File #: PC Reso 04-2017, **Version:** 1

Resolution to approve a planned development overlay for 5530 South Curtice Street.

Project Name: Curtice Street Duplex

Application Type: Planned Development Overlay

Figure 3.
Context for the proposed 16-foot front setback, from the PDO plan set.

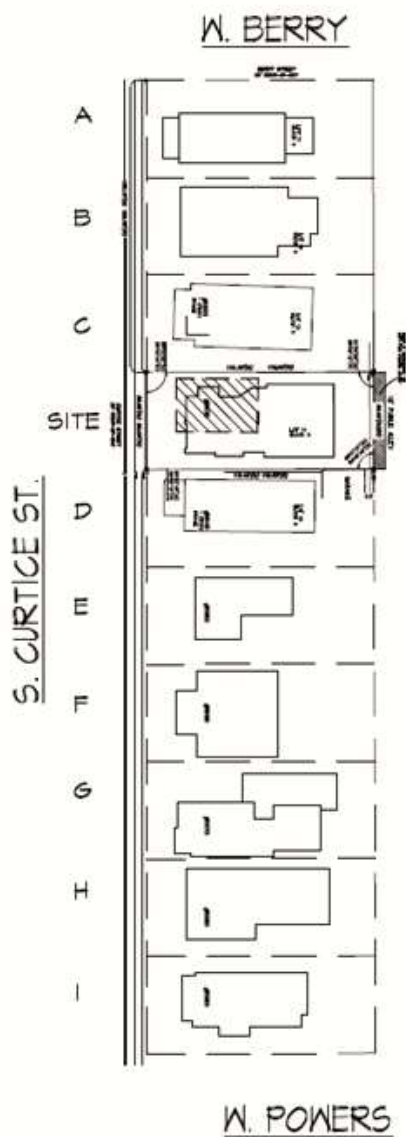
The applicant has provided an analysis of how the proposed setback and height variations are consistent with the existing land use characteristics of the district. (please refer to attached Letter of Intent). In the letter, the applicant states that the proposed modifications would not have a detrimental effect on the character of the neighborhood. With respect to the front setback, the proposed 16-ft. setback appropriate in that it is consistent with the predominant front setback for the block face, which has an average of 15.95-foot front setback, as shown in figure 3. The applicant states that the reduced side setback for the south lot is consistent with the existing character of the block as other homes have narrow side yard setbacks. With respect to height, the applicant states that the proposed 31-ft. tall building, which is 1-ft. greater than the allowable 30-ft. height, will not have a significant visual impact within the neighborhood.

Staff concurs with the applicant's analysis of the proposed setback and height variations with respect to the development pattern in the R-5 district. Further, the development is a benefit to the city: its proposed architectural design is of high quality, utilizing building materials and architectural features that are commonplace on South Curtice Street; the architectural style is based on the craftsman style, which will be complementary to the older homes within the neighborhood, helping to preserving its character; and it provides a new construction option to the neighborhood. Further, the duplex would not impair the intent of the land used code, which allows both single family and multifamily development in the R-5 zone.
